Rest Acres Road, Highway 403 to King Edward Street

Class Environmental Assessment Addendum

Prepared for: The County of Brant

January 2018

Figure 4: Alternatives 1A-C and 2 shown at PIC

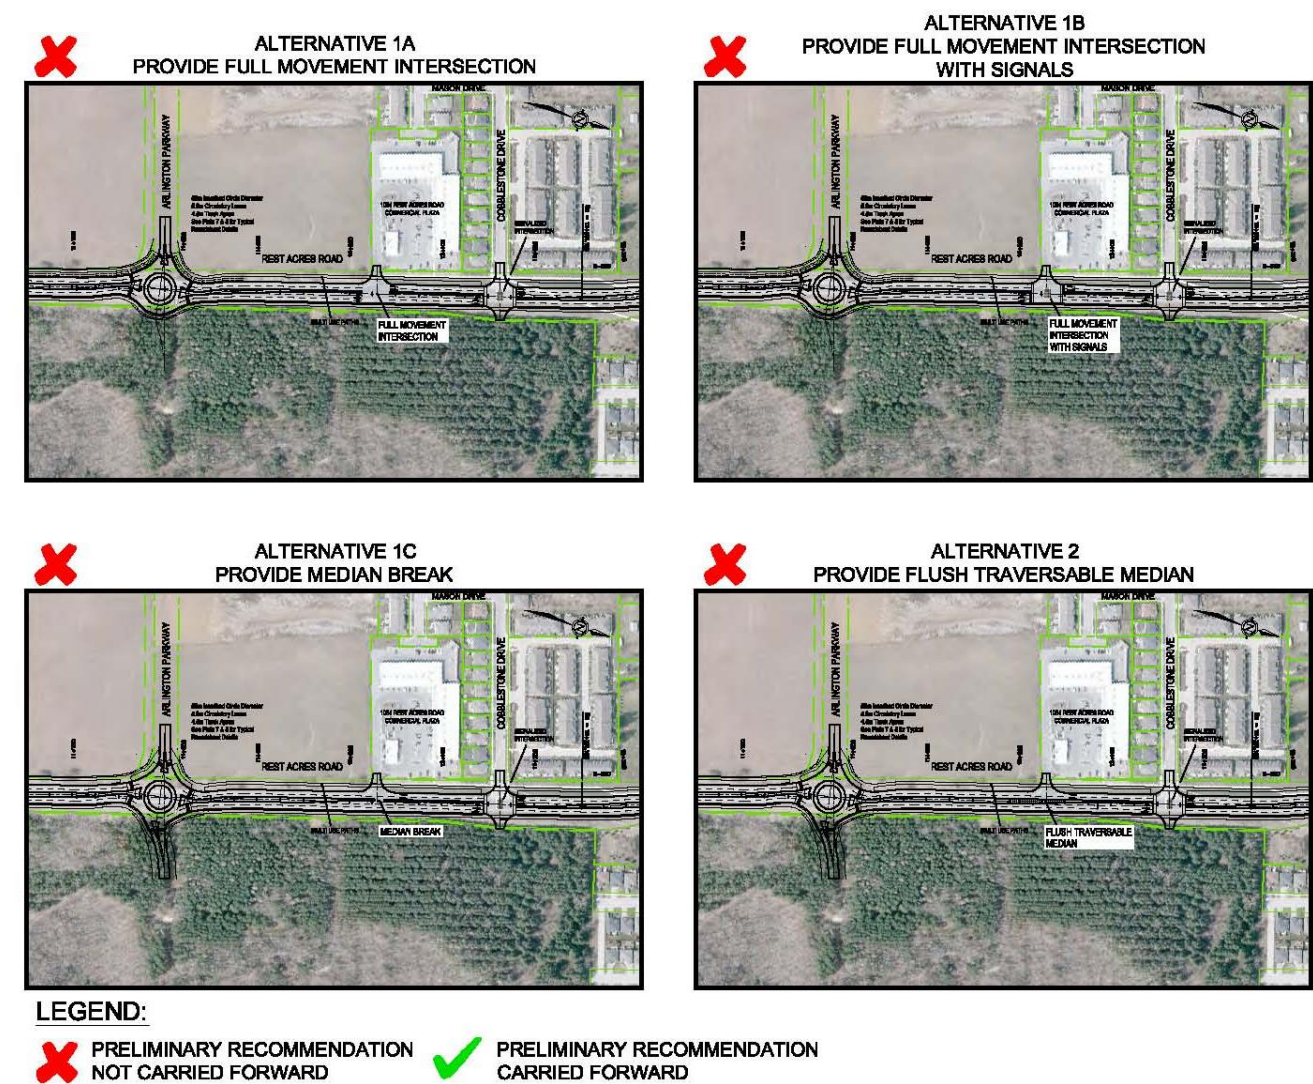
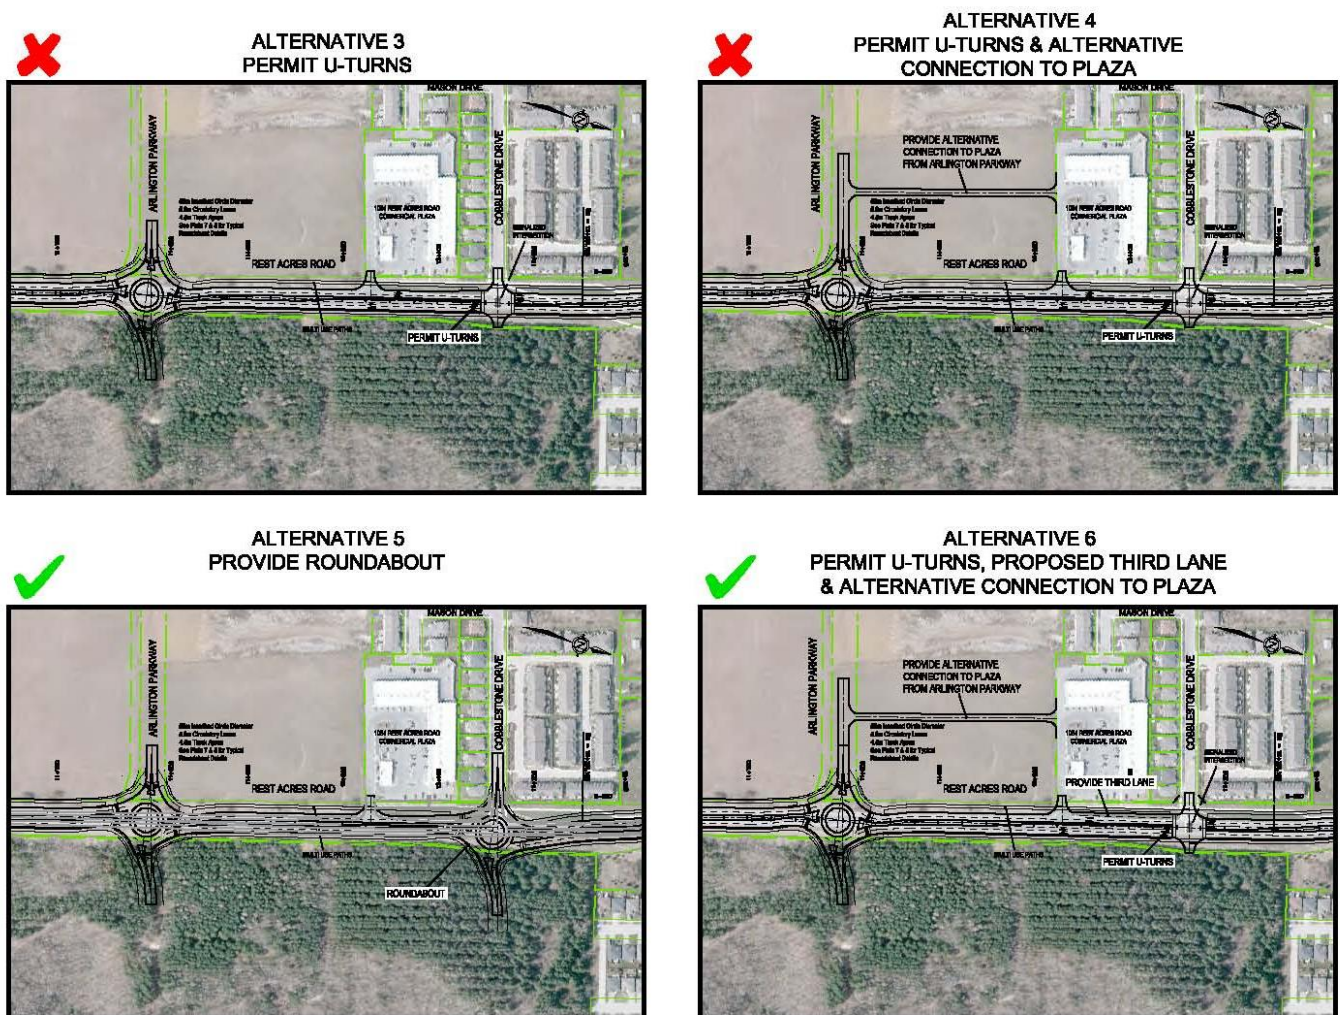
- 5) Staging Plan for 1084 Rest Acres Road Plaza intersection control which includes adjacent Cobblestone intersection. The eight alternatives considered between the Arlington Parkway and Cobblestone Drive to accommodate access to the 1084 Plaza (shown at the Public Information Centre (PIC)) are illustrated in **Figure 4** and **Figure 5**;

Eight alternatives were considered between the Arlington Parkway and Cobblestone Drive for access to the commercial plaza at 1084 Rest Acres Road, as illustrated in **Figure 4** and **Figure 5**. The alternatives considered included:

- **Alternative 1A:** Do Nothing: Median break, full movements at unsignalized intersection
- **Alternative 1B:** Full movements with Traffic Signals
- **Alternative 1C:** Median break allows NB left turns (3/4 intersection)
- **Alternative 2:** Flush traversable median
- **Alternative 3:** Permissive U-turns at Cobblestone. Entrance a right-in/right-out
- **Alternative 4:** Permit U-turns at Cobblestone and provide alternative access through commercial property to south
- **Alternative 5:** Roundabout at Cobblestone Drive
- **Alternative 5B:** Roundabout at Cobblestone Drive shifted easterly
- **Alternative 6:** Permissible U-turn at Cobblestone, exclusive auxiliary lane for SB drivers, and a frontage road/internal access road southerly to Arlington Parkway

This initial assessment recommended Alternative 6 and the recommendation was presented at the PIC. Based on comments received at the PIC, two refinements to Alternative 5 were investigated. One refinement was to shift the Cobblestone roundabout easterly to avoid property impacts to existing buildings and change the property acquisition to be from development lands east of Rest Acres Road. This revised Alternative 5 is and is labelled Alternative 5B and is illustrated in **Figure 6**. The second refinement was to accept staging of the access control (delay loss of access) to allow a reduction of business impacts.

**Figure 6: Alternative 5B**

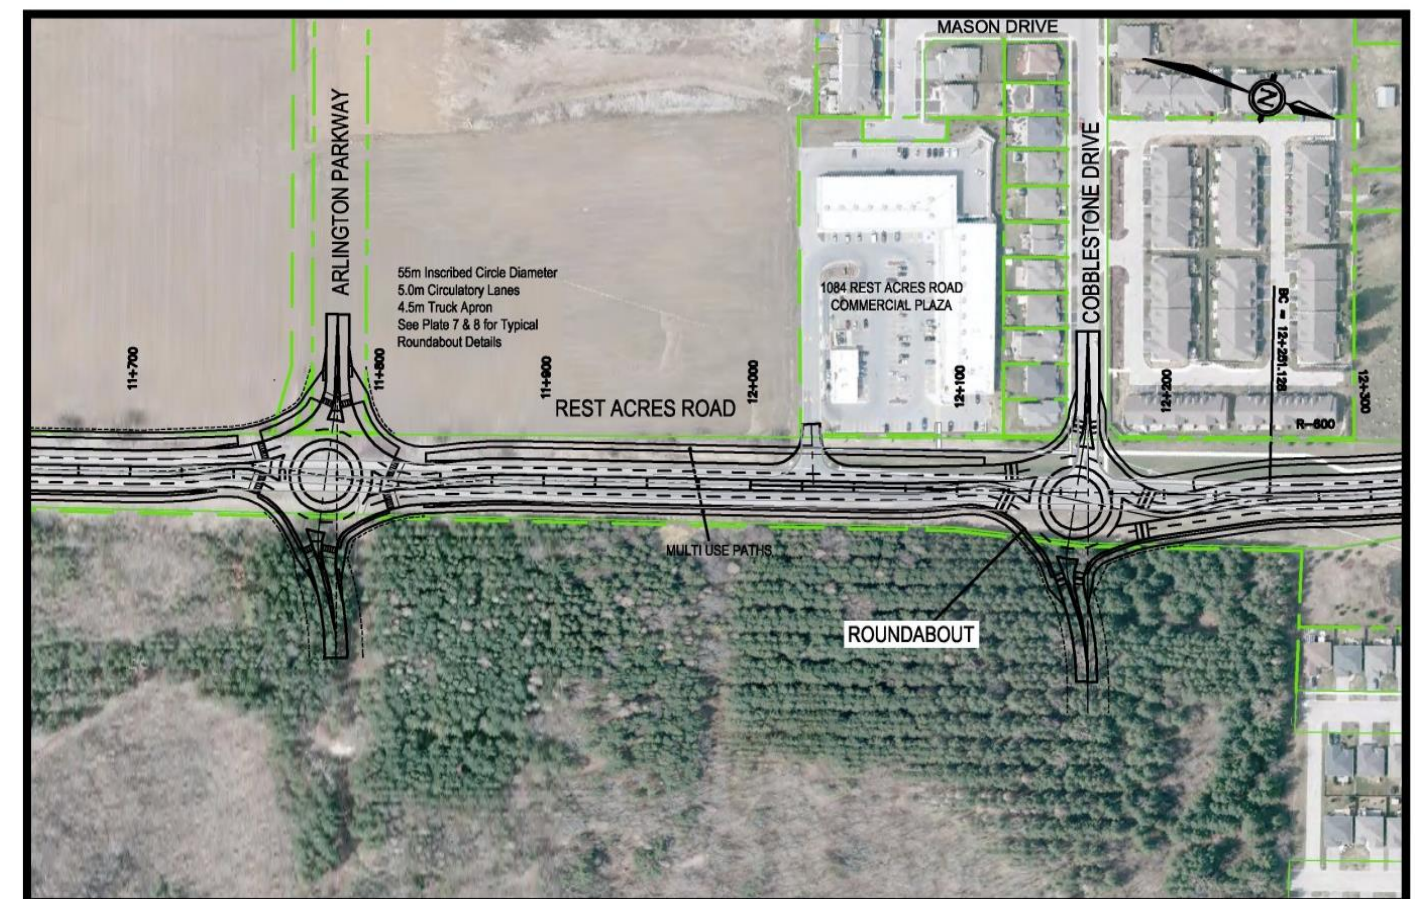
Based on the meeting on September 19, 2017, **the recommended alternative was changed to Alternative 5B**. Alternative 5B is illustrated in **Figure 6** and plates in **Section 12.0**.

- a. Long Term Plan: The Class EA Addendum would include the consideration for an offset roundabout at Cobblestone Drive. This avoids the residential properties, improves the access to the 1084 site and would have

land requirements to the east. The 1084 site access would be converted to a right-in and right-out driveway and be bookended with roundabouts to the north and south, and include a joint internal access between commercial lots.

- b. Interim Plan: An interim plan would be implemented that would allow northbound left turns into the site from Rest Acres Road. Exiting traffic would be restricted to right only (southbound) directed to the roundabout. The timeline for the interim period would be for 5 to 10 years based on the following triggers:

**Figure 7: Revised Roundabout Location between Edgar Place and Vic Chambers Place**

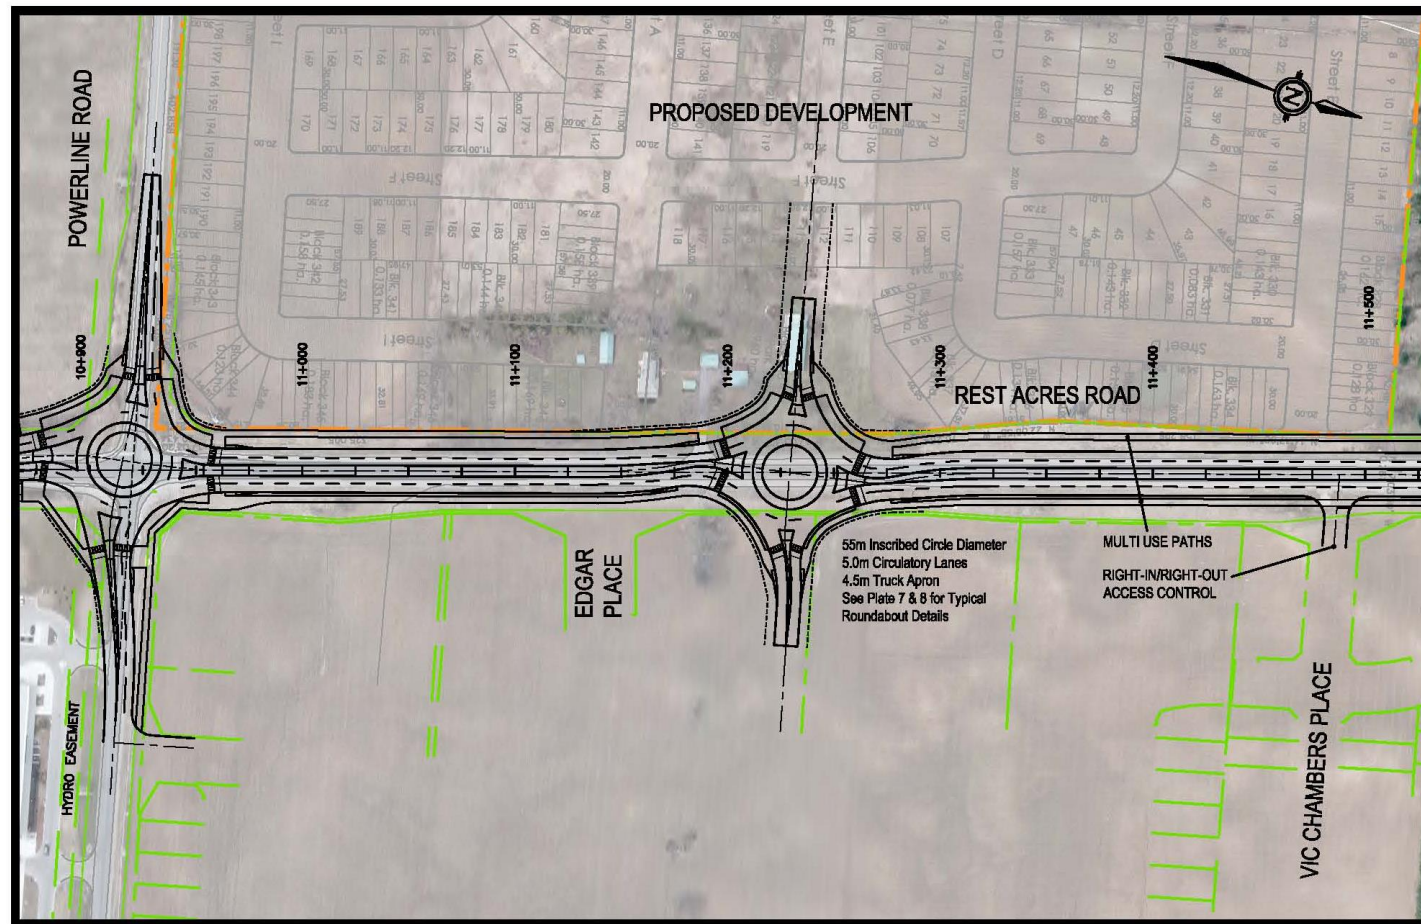
Following the PIC the landowners, who are developing the adjacent land parcels east and west of Rest Acres Road in the road segment from Powerline Road to Vic Chambers Place, requested consideration of a modification to the location of the Vic Chambers roundabout. This revision would be to shift the roundabout to a location between the former Edgar Place and Vic Chambers intersections (approximate chainage 11+220). The revised roundabout location is illustrated in **Figure 7**. On September 19, 2017 the modified intersection location was discussed at a meeting with the landowners. The updated roundabout location and design have been accepted by the landowners and County and this Class EA Addendum report documents this change as documented in **Appendix D**.

Following the recommendation for a roundabout at Vic Chambers Place, which was presented at the PIC in 2017, a meeting was held with the property owner. It was agreed at the meeting that the roundabout at Vic Chambers Place would be replaced with a right-in/right-out intersection and that the roundabout initially proposed at Edgar Place would be relocated to Lydia Lane, approximately 90 m to the north, to better integrate with the land use plans proposed by the developers. The modified location is reflected in the Recommended Plan in **Section 12.0: Plates**. The notes of the meeting can be found in **Appendix D**.

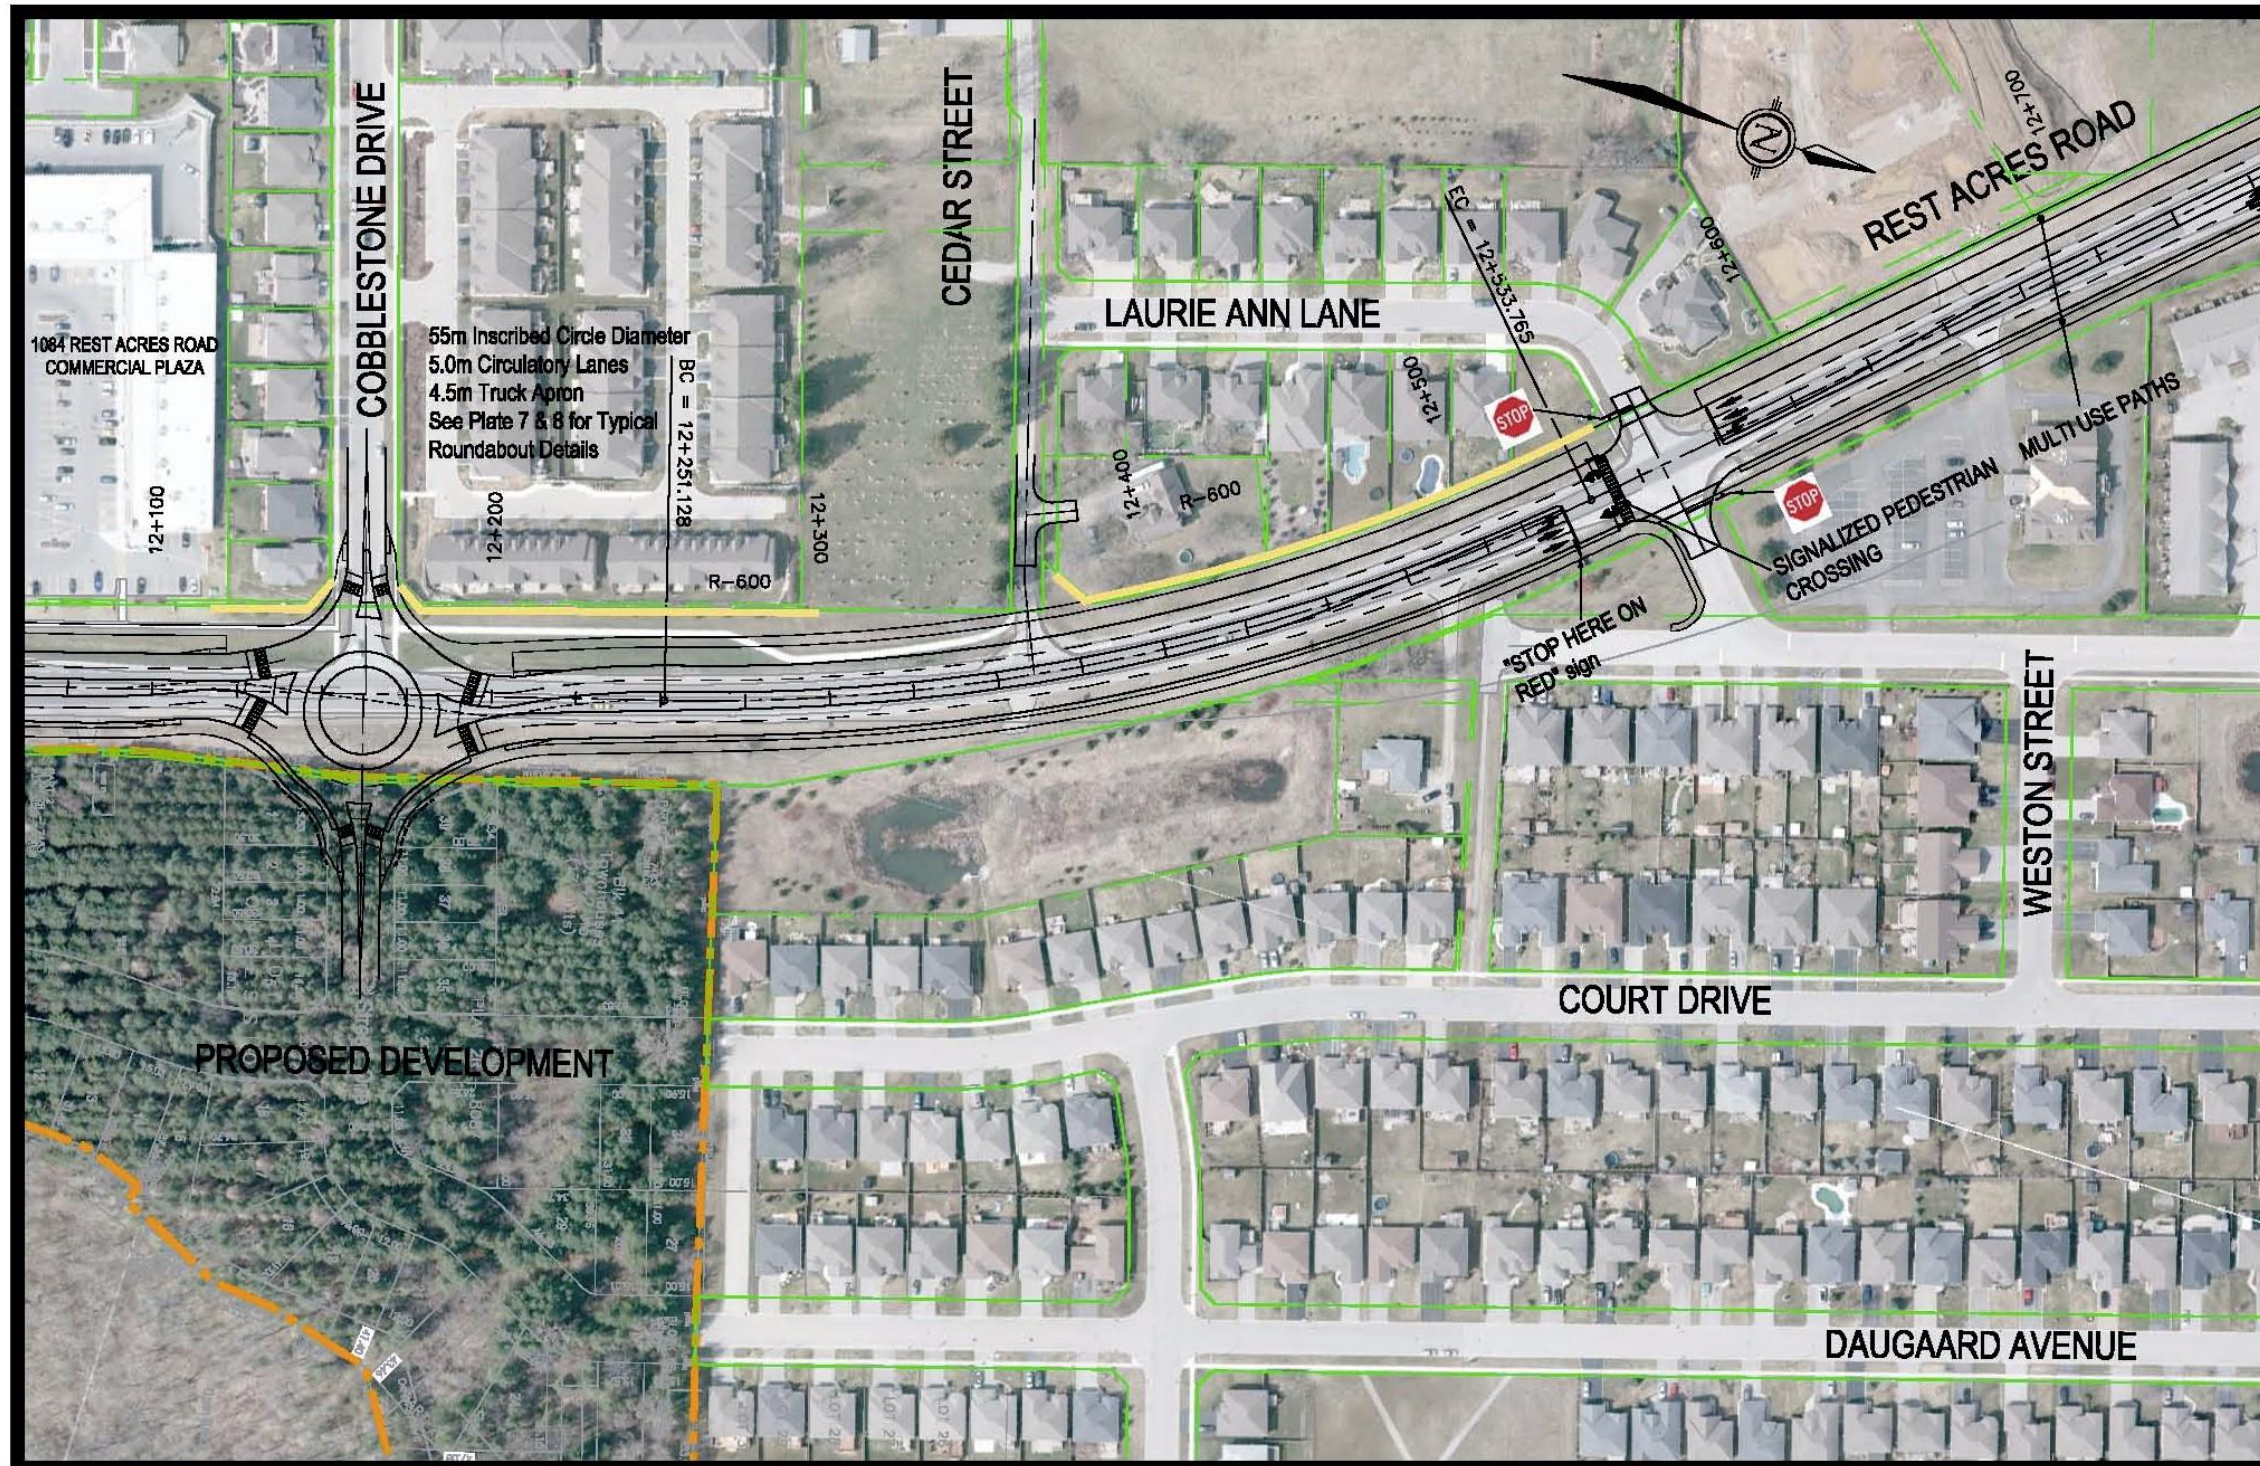
A collaborative discussion between Vicano Developments (the owner of 1084 Rest Acres Road), the County and consultant led to the following proposal that was accepted by the County and Vicano Developments as a favourable stepped approach to implementing longer term roadway improvements.

**Long Term Plan:** The Class EA Addendum would include the consideration for an offset roundabout at Cobblestone Drive. This avoids the residential properties, improves the access to the 1084 site and would have land requirements to the east. Meetings will be scheduled with these land owners. The 1084 site access would be converted to a right-in and right-out driveway and be bookended with roundabouts to the north and south and include a joint internal access between commercial lots. The County would provide temporary signage for a 3 month period following closure of the left turn access.

**Interim Plan:** An interim plan would be accepted that would allow northbound left turns into the site from Rest Acres. Exiting traffic would be restricted to right only (southbound) directed to the roundabout.
